NOTICE OF PROPOSED DEVELOPMENT

**ONE LOT SUBDIVISION & BOUNDARY ADJUSTMENT
(RE-ADVERTISED)**

APPLICATION NO: SA 2024 / 27 1

BUSHFIRE ASSESSMENT REPORT

Existing Site Plan

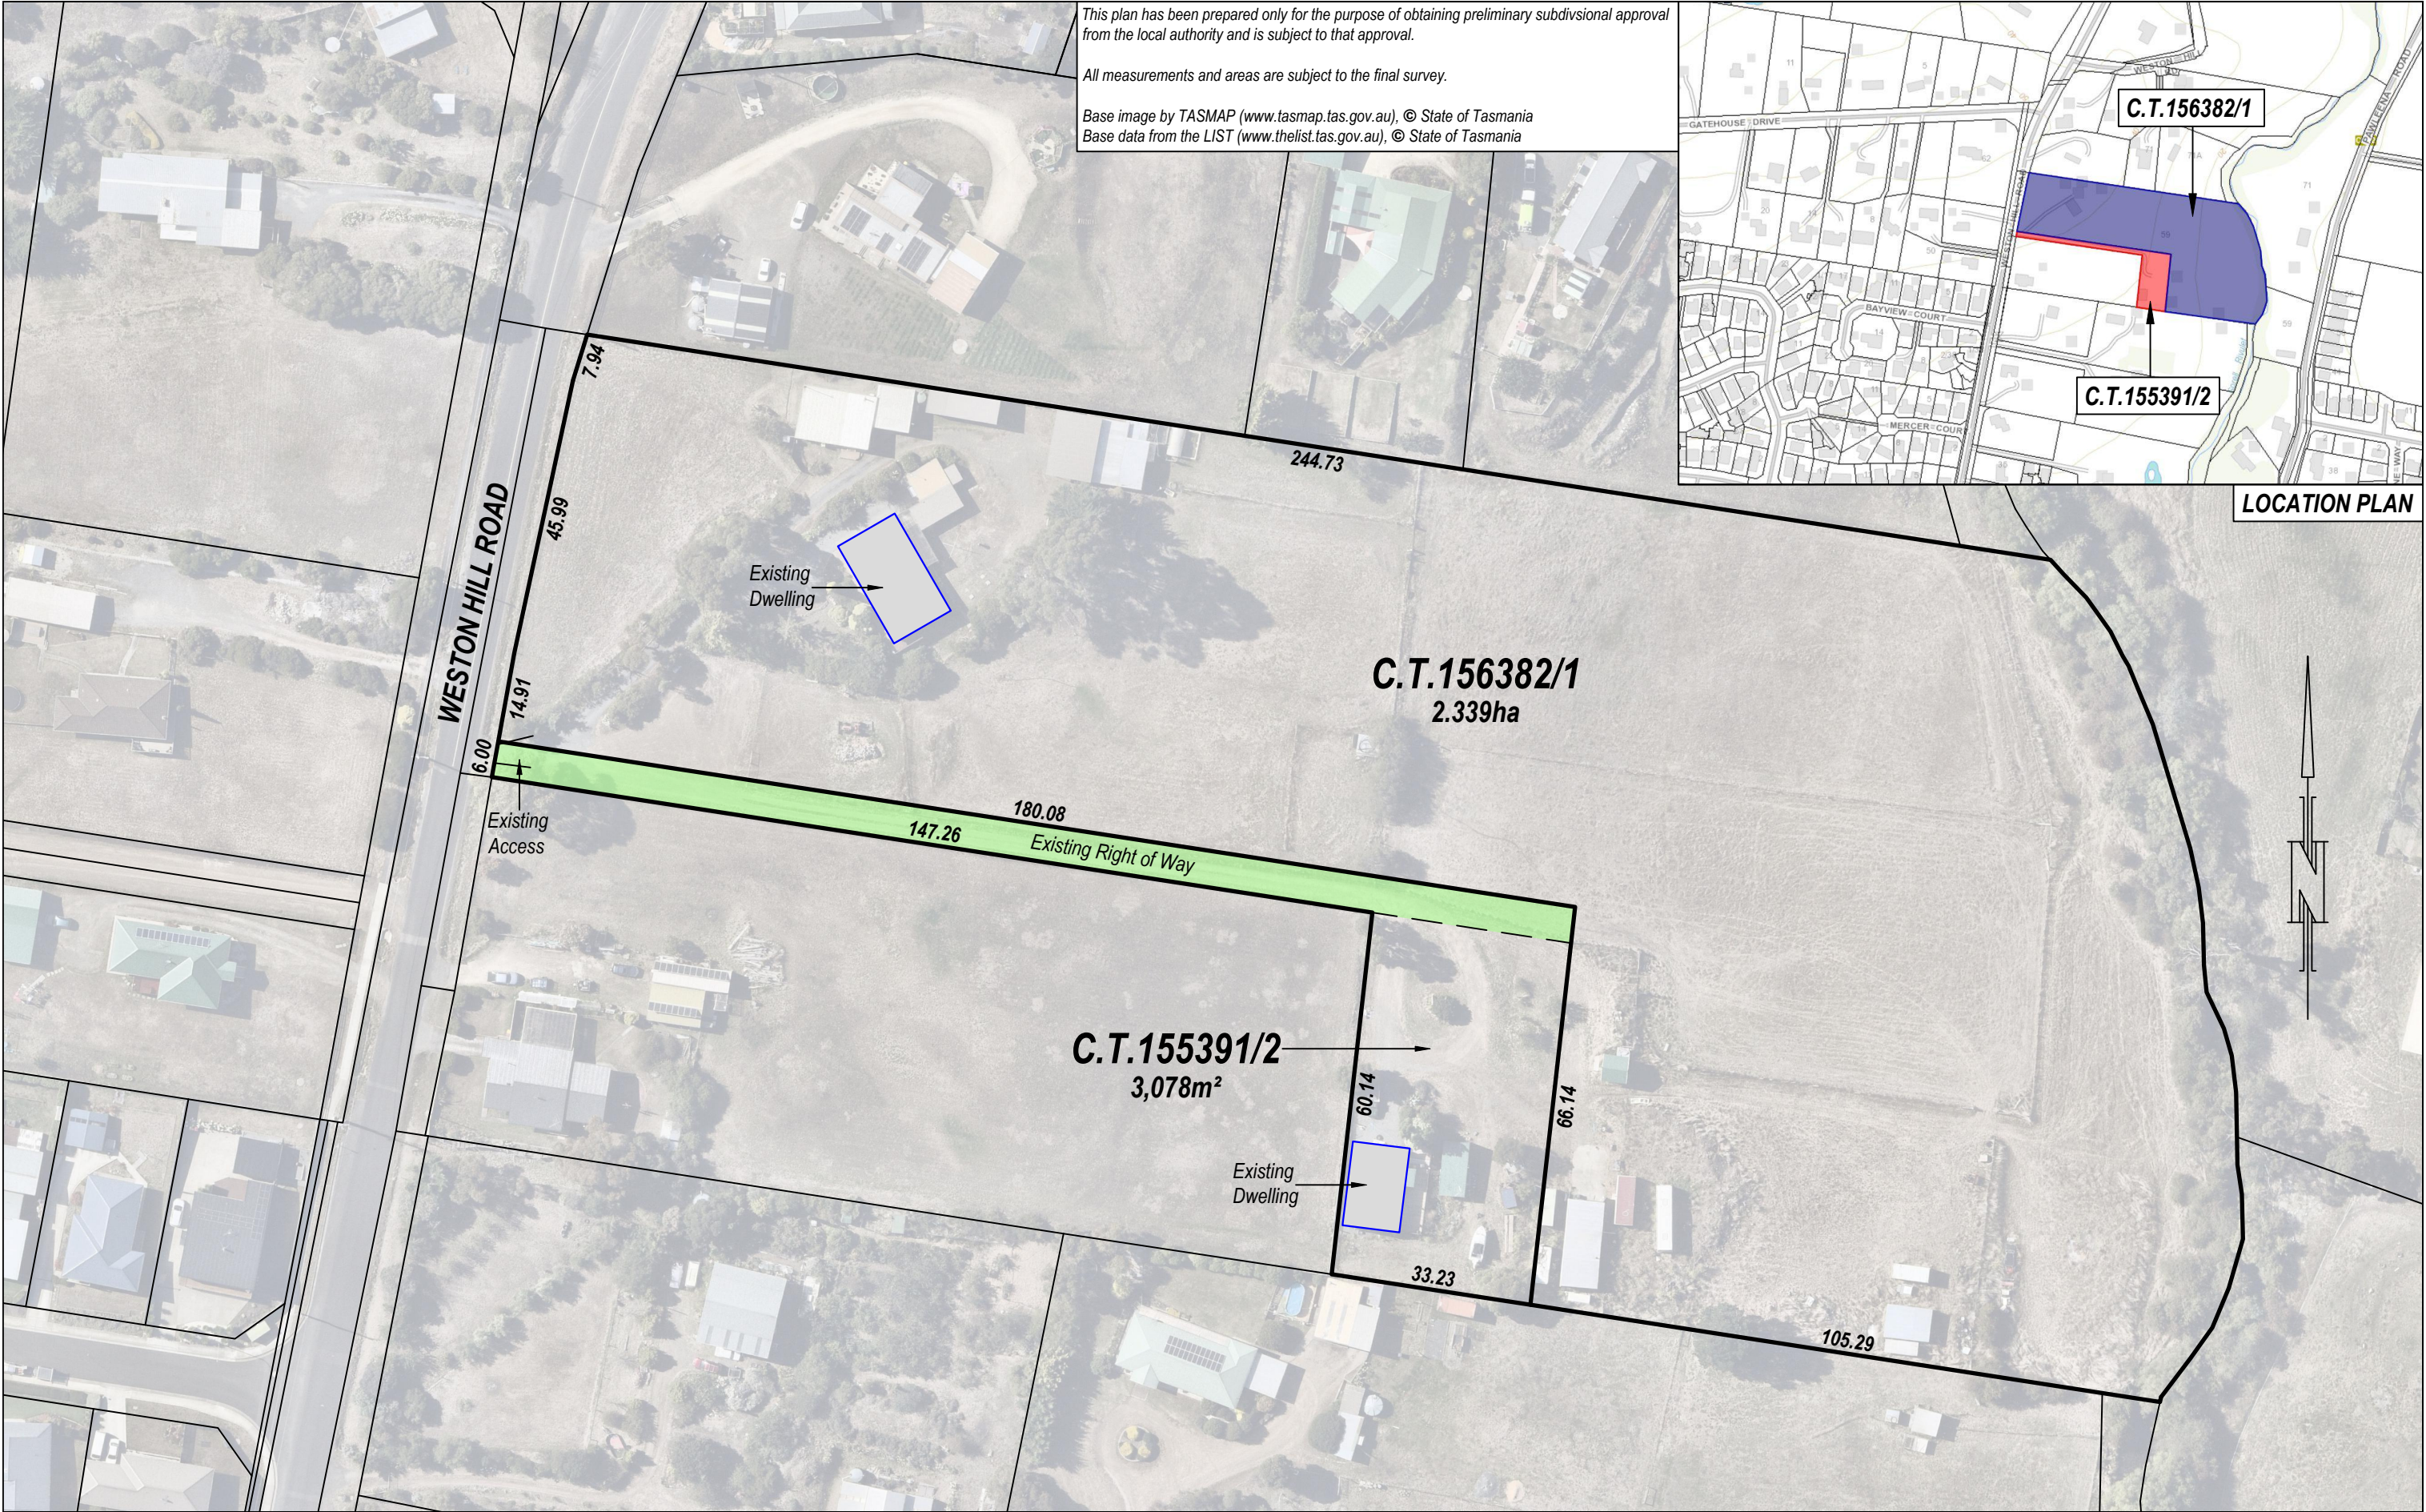
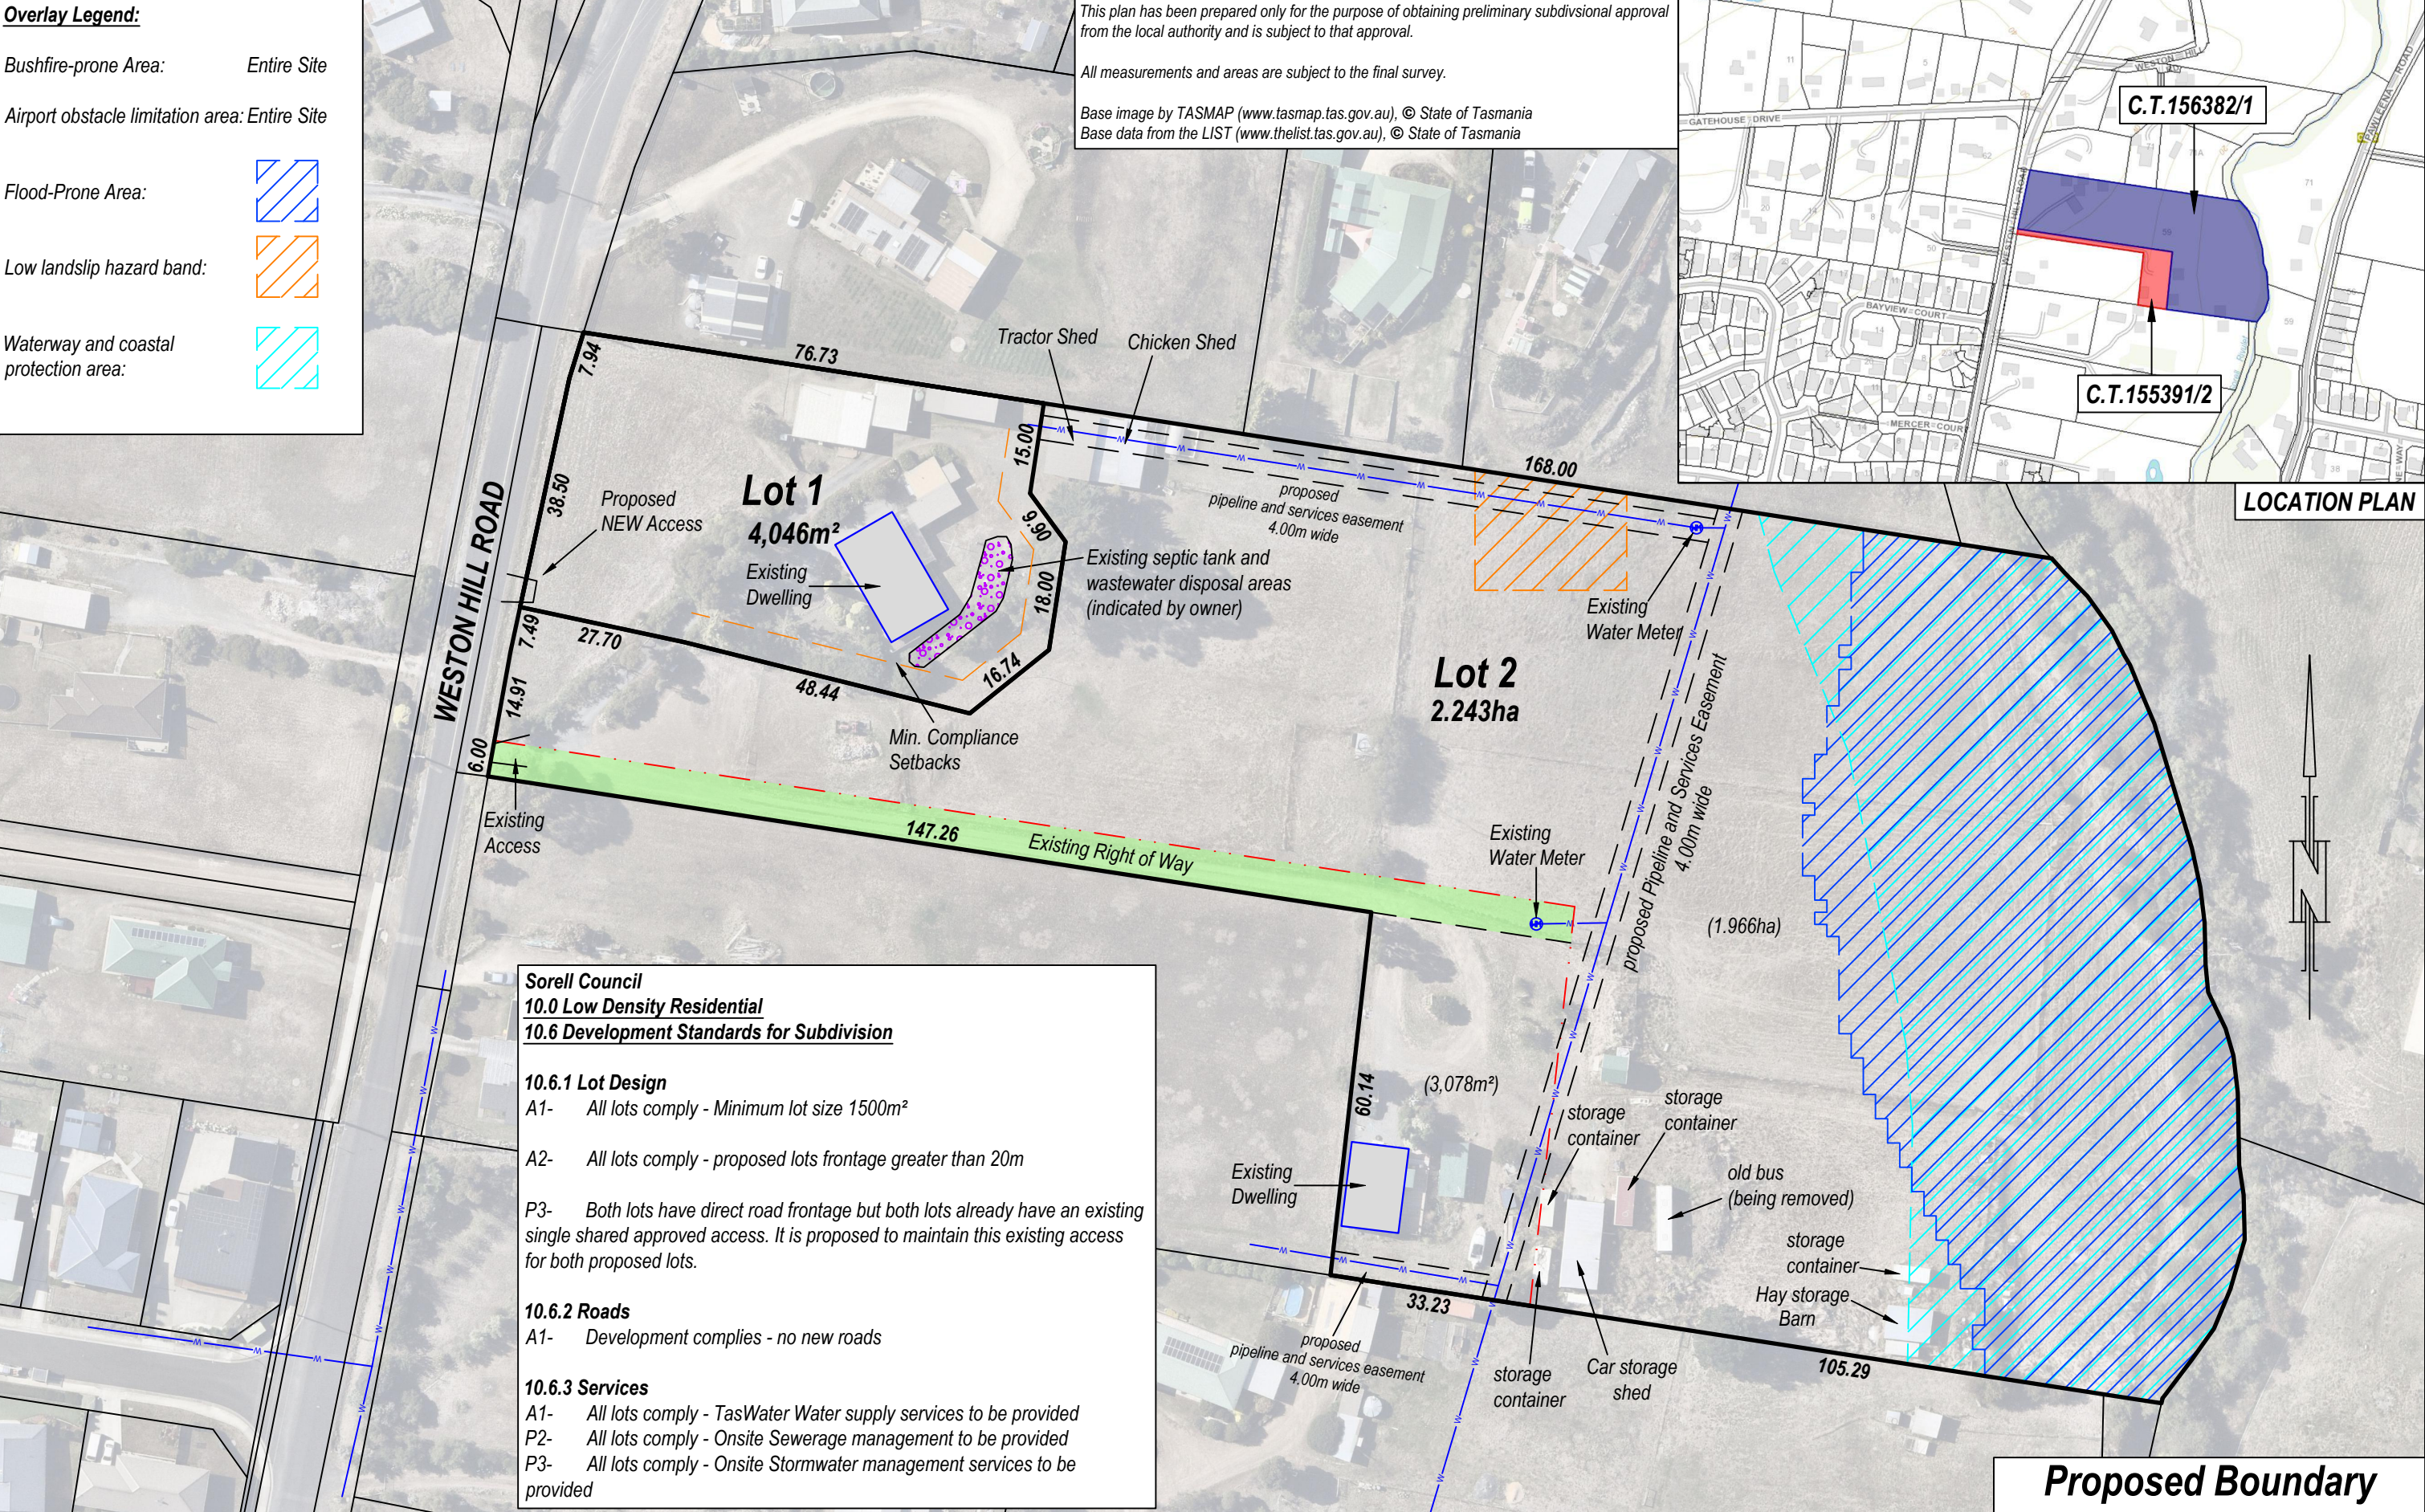
Further to discussions with council's planner, Shannon McCaughey please find enclosed an amended proposal plan.

- Boundary between proposed Lot 1 & 2 shifted to give greater separation to the wastewater disposal area on Lot 1.
- New separate access provided for proposed Lot 1. Previous Right of Way to Lot 1 also removed.
